Our reference: SDA-0517-039422
Your reference: JZA:MD011:MCU17/0095
Applicant reference: 16439

Amended concurrence agency response—with conditions

David Low Way and 17 & 28 Belle Mare Avenue, Yaroomba QLD 4573 – Lots 12, 15 and 16 on SP238214, Lots 20, 336-340 on SP219217 and Lot 25 on SP269561
(Given under section 290(1)(b) of the *Sustainable Planning Act 2009*)

**Item 4.1.1 Development Application for Material Change of Use (Preliminary Approval),
Material Change of Use (Development Permit) and Reconfiguration of a Lot
(Development Permit) - David Low Way, Yaroomba**
Attachment 5 State Government Concurrence Agency Response

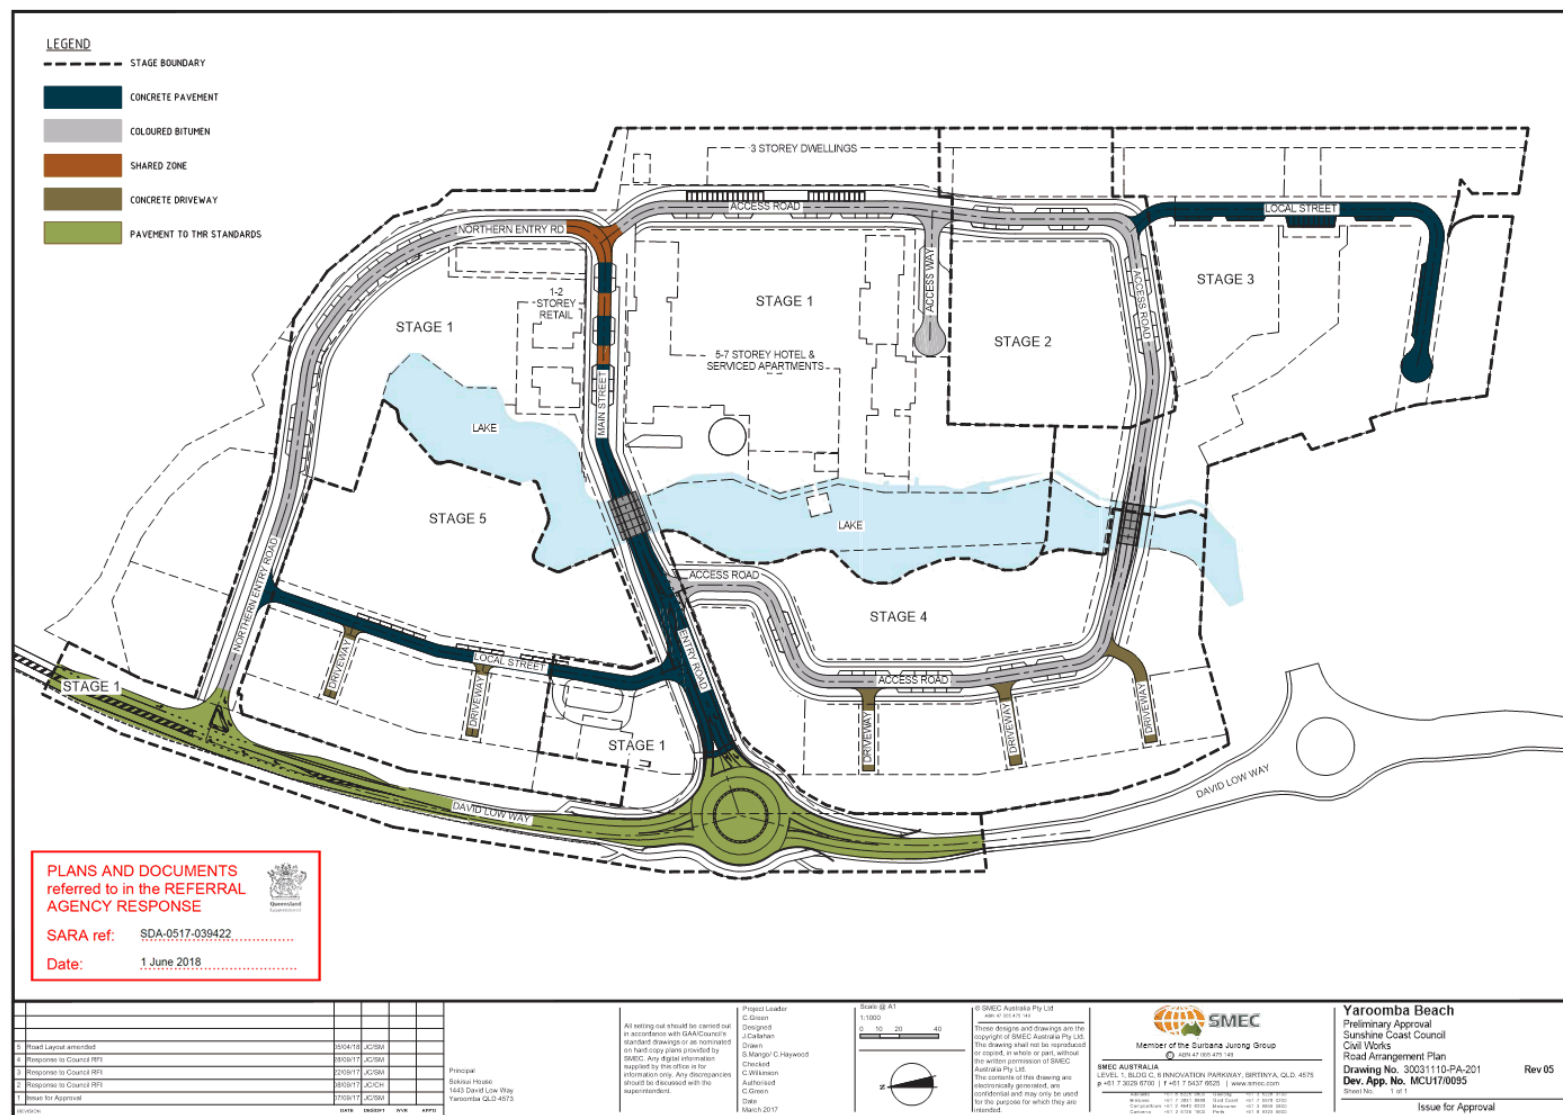
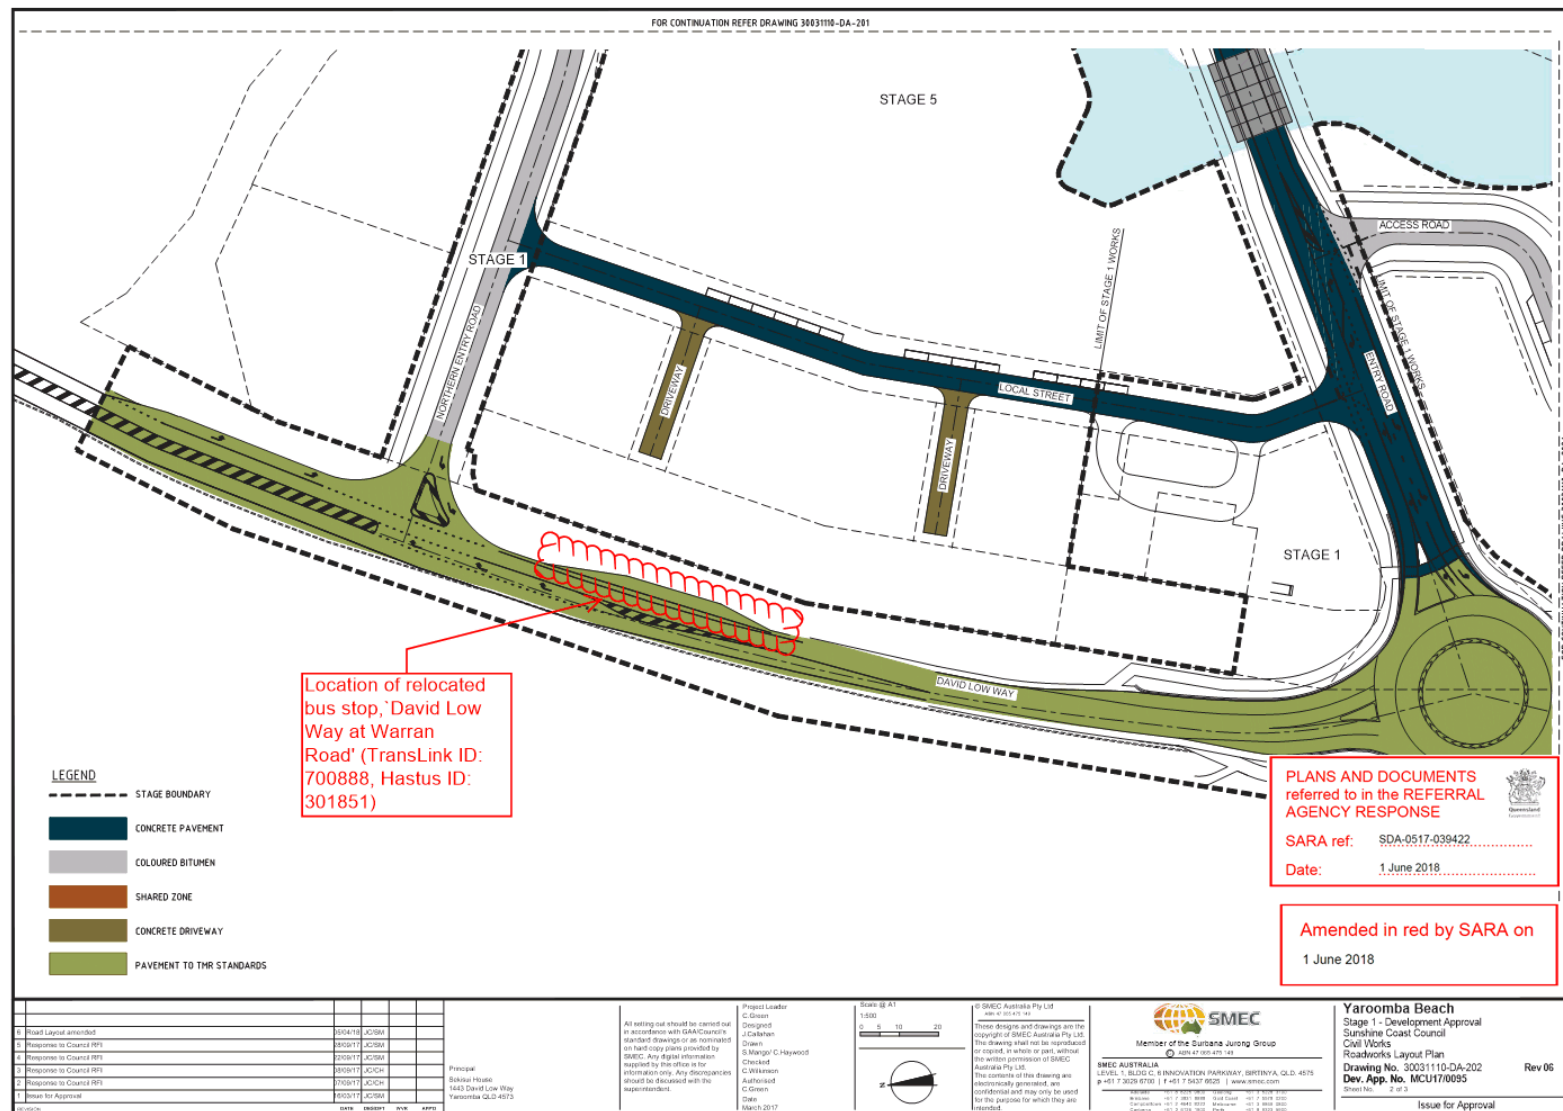
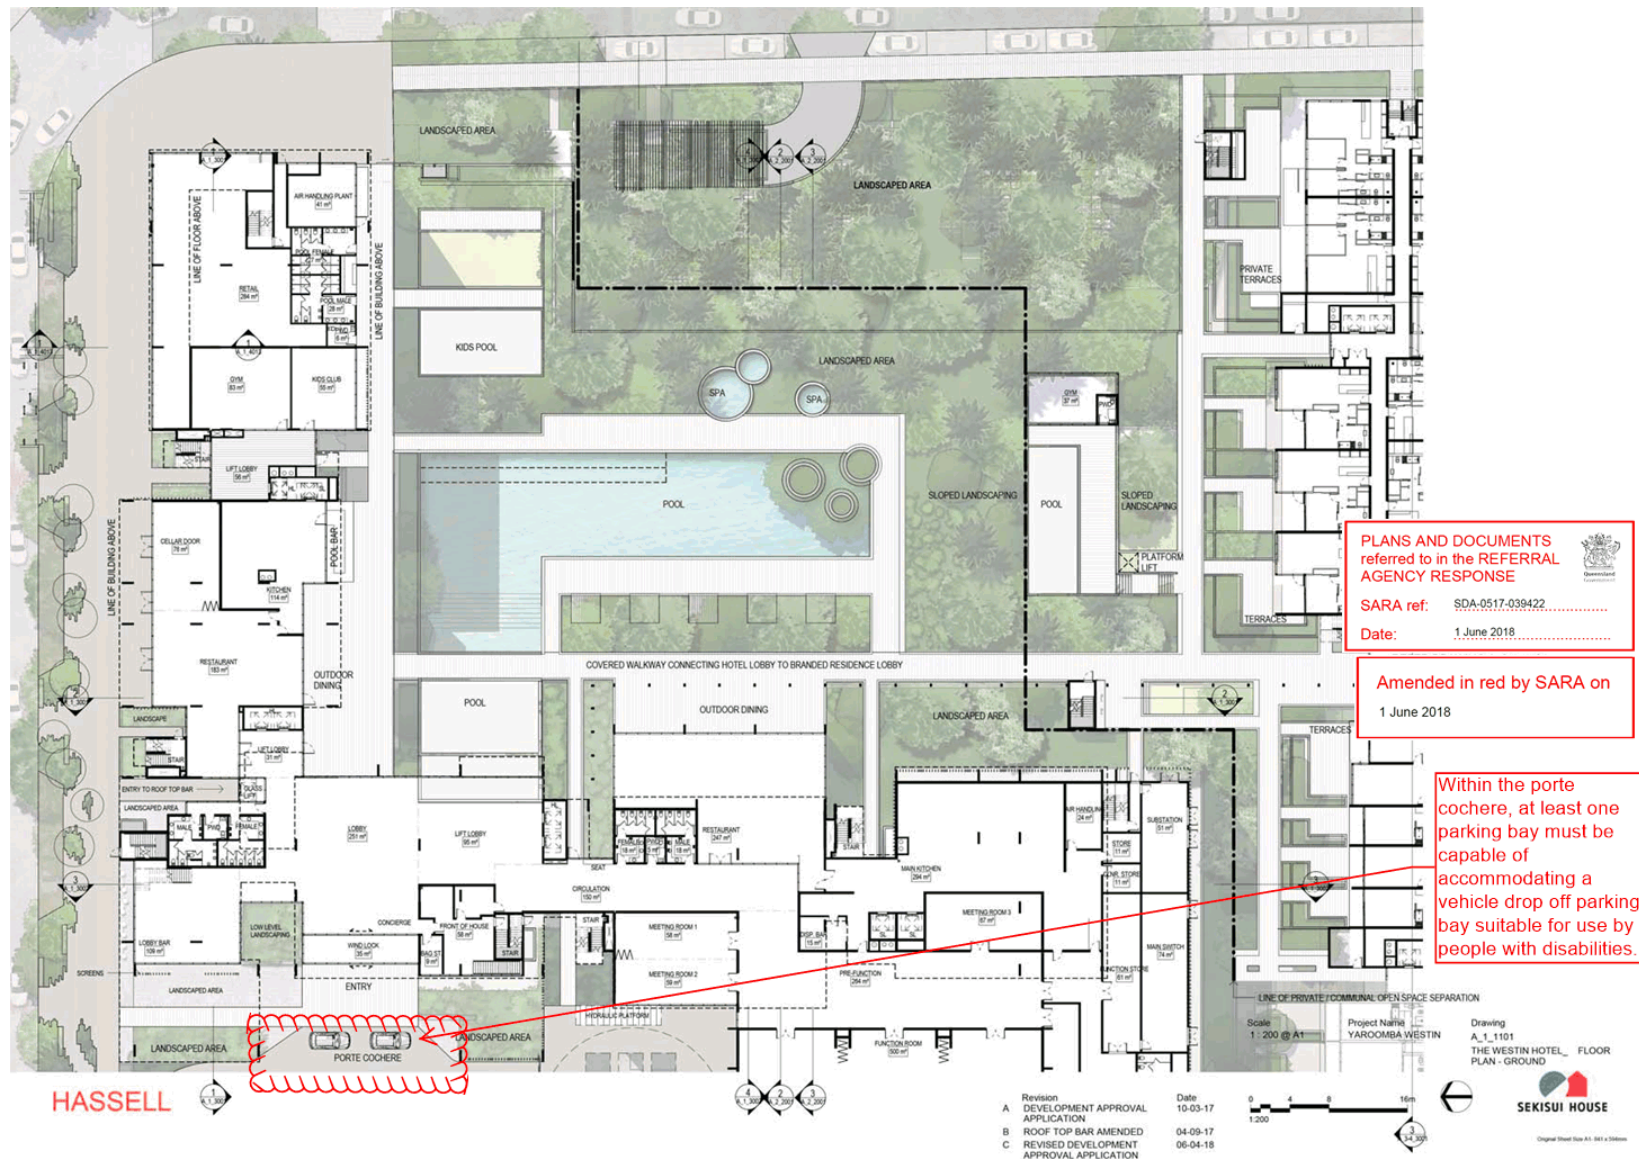
| 16. | <p>(a) The porte cochere shown on The Westin Hotel_Floor Plan – Ground, prepared by Hassell, dated 06/04/2018, drawing number A_1_1101 and revision C, as amended in red, and the drop off shown on the 'Serviced Apartments_Floor Plan – Ground', prepared by Hassell, dated 06/04/2018, drawing number A_3-4_1101 and revision B, as amended in red, must each be designed and constructed to ensure that at least one parking bay is capable of accommodating a vehicle drop off parking bay suitable for use by people with disabilities.</p> | <p>Prior to commencement of use and to be maintained at all times for the relevant stage</p> |

Figure 6-4: Proposed Intersection Layout of David Low Way/Beach Road

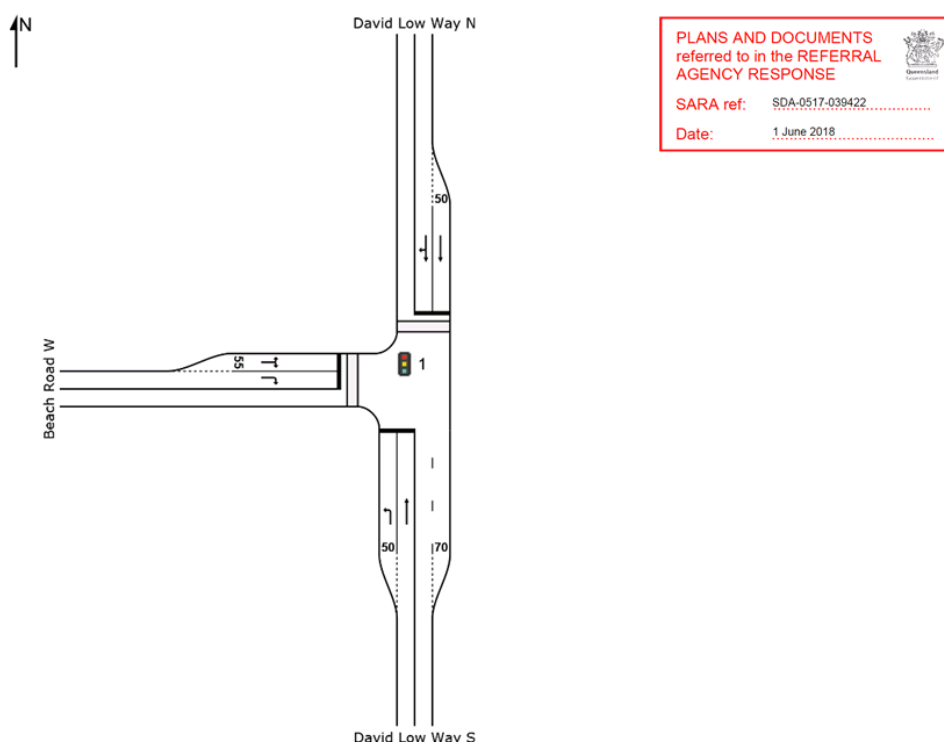
| 7. | <p>(a) Road works comprising increased turning lanes and lane reconfiguration must be provided generally in accordance with Figure 6-4: Proposed Intersection Layout of David Low Way/Beach Road in the Yaroomba Beach Village & Resort Traffic Impact Assessment Report prepared by SMEC Australia Pty Ltd, dated 06/04/2018 and revision 4.</p> <p>(b) The road works must be designed and constructed in accordance with the Road Planning and Design Manual 2nd Edition, Department of Transport and Main Roads, 2016.</p> | Prior to the commencement of use of any material change of use sought pursuant to this preliminary approval |

| 14. | <p>(a) Road works comprising increased turning lanes and lane reconfiguration must be provided generally in accordance with Figure 6-4: Proposed Intersection Layout of David Low Way/Beach Road in the Yaroomba Beach Village & Resort Traffic Impact Assessment Report prepared by SMEC Australia Pty Ltd, dated 06/04/2018 and revision 4.</p> <p>(b) The road works must be designed and constructed in accordance with the Road Planning and Design Manual 2nd Edition, Department of Transport and Main Roads, 2016.</p> | Prior to the commencement of use |

Figure 7-1: Proposed Intersection Layout of David Low Way/Development Main Access

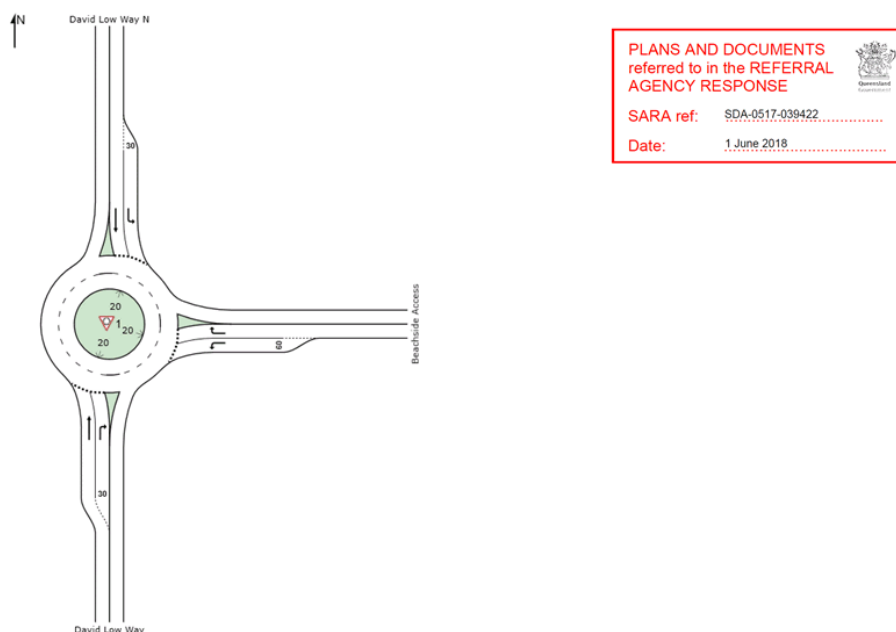
| | <p>Sunshine Coast Council Civil Works Road Arrangement Plan', prepared by SMEC Australia Pty Ltd, dated 28/09/2017, reference 30031110-PA-201 and revision 4.</p> <p>(b) Road access works comprising:</p> <ul style="list-style-type: none"> i. a roundabout must be provided generally in accordance with Figure 7-1: Proposed Intersection Layout of David Low Way/Development Main Access of the Yaroomba Beach Village & Resort Traffic Impact Assessment Report prepared by SMEC Australia Pty Ltd, dated 06/04/2018 and revision 4; and ii. a left-in / left-out / right-in access with auxiliary left turn (AUL) treatment and channelised right turn treatment (CHR) and the no right-out physically reinforced must be provided generally in accordance with Figure 7-2: Proposed Intersection Layout of David Low Way/Development Northern Access of the Yaroomba Beach Village & Resort Traffic Impact Assessment Report prepared by SMEC Australia Pty Ltd, dated 06/04/2018 and revision 4. <p>(c) The road access works must be designed and constructed in accordance with the Road Planning and Design Manual 2nd Edition, Department of Transport and Main Roads, 2016.</p> | <p>(b) Prior to the commencement of use</p> <p>(c) Prior to the commencement of use</p> |

Figure 7-3: Proposed Intersection Layout of David Low Way/Suncoast Beach Blvd

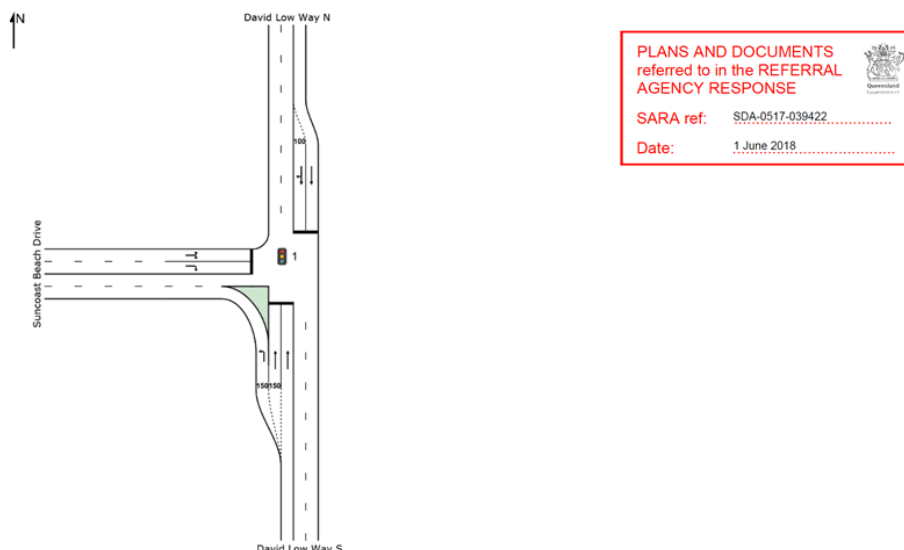
| 6. | <p>(a) Road works comprising signalisation must be provided generally in accordance with Figure 7-3: Proposed Intersection Layout of David Low Way/Suncoast Beach Blvd in the Yaroomba Beach Village & Resort Traffic Impact Assessment Report prepared by SMEC Australia Pty Ltd, dated 06/04/2018 and revision 4.</p> <p>(b) The road works must be designed and constructed in accordance with the Road Planning and Design Manual 2nd Edition, Department of Transport and Main Roads, 2016.</p> | Prior to the commencement of use of any material change of use sought pursuant to this preliminary approval |

| 13. | <p>(a) Road works comprising signalisation must be provided generally in accordance with Figure 7-3: Proposed Intersection Layout of David Low Way/Suncoast Beach Blvd in the Yaroomba Beach Village & Resort Traffic Impact Assessment Report prepared by SMEC Australia Pty Ltd, dated 06/04/2018 and revision 4.</p> <p>(b) The road works must be designed and constructed in accordance with the Road Planning and Design Manual 2nd Edition, Department of Transport and Main Roads, 2016.</p> | Prior to the commencement of use |

YAROOMBA BEACH SUBDIVISION
STAGE 1

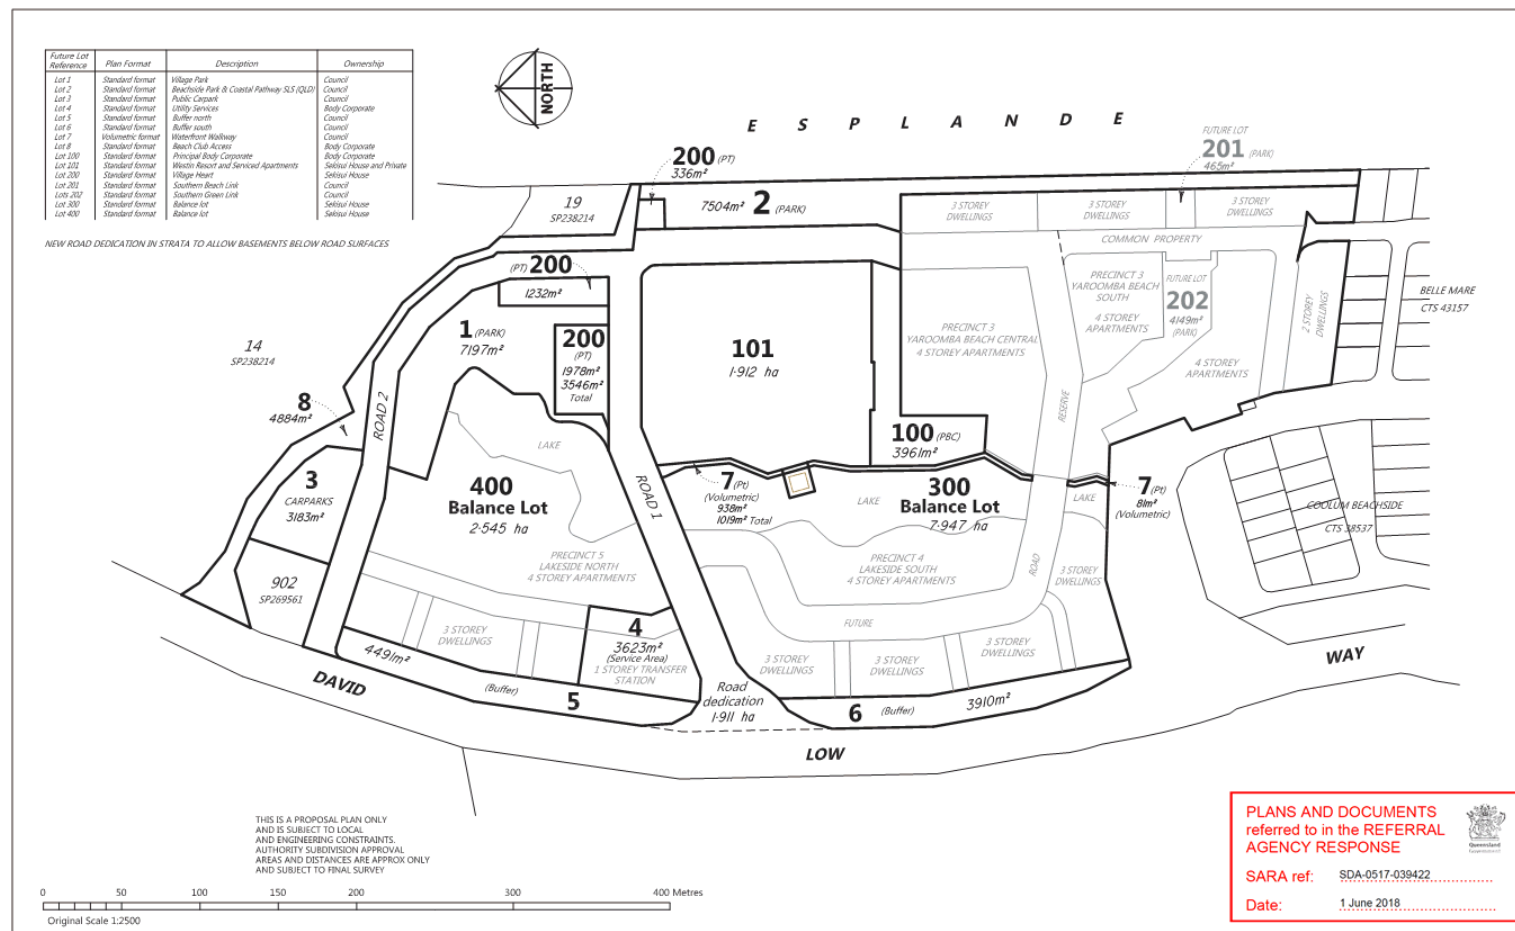
| 17. | Carry out the reconfiguration of lot in accordance with the 'Yaroomba Beach Subdivision - Stage 1', prepared by Project Urban, dated 28/03/2018 and drawing number 16439.2. | At the time of survey plan registration |
